**STAFF REPORT: JUNE 14, 2023 REGULAR MEETING**  
**APPLICATION NUMBER: 23-8401**  
**ADDRESS: 2984 IROQUOIS**  
**HISTORIC DISTRICT: INDIAN VILLAGE**  
**APPLICANT/OWNER: MARK REYNOLDS**  
**DATE OF PROVISIONALLY COMPLETE APPLICATION: MAY 7, 2023**  
**DATE OF STAFF SITE VISIT: MAY 25, 2023 AND JUNE 5, 2023**

**SCOPE: INSTALL DRIVEWAY GATE**

*May 2023 photo by staff.*

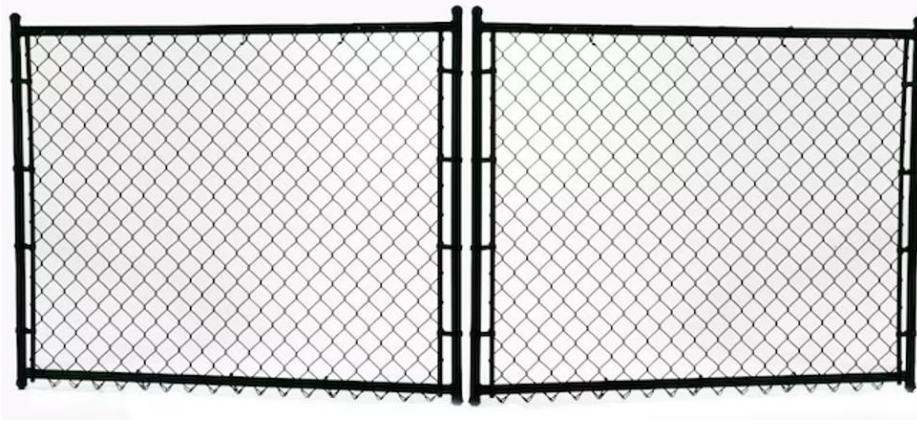
The subject property, historically known as the Robert T. Herdegan House and designed by Roland C. Gies, consists of a Tudor Revival house, behind which sits a smaller carriage house. The house was built in 1917. Both the buildings feature distinctive thatch-like wooden shingle roofs, stucco cladding, mullioned sash and casement windows, rowlock brick sills, and brick foundations. The rear yard is partially surrounded by a parged masonry wall (subject of this application), its perimeter completed with expanses of chain link fence.
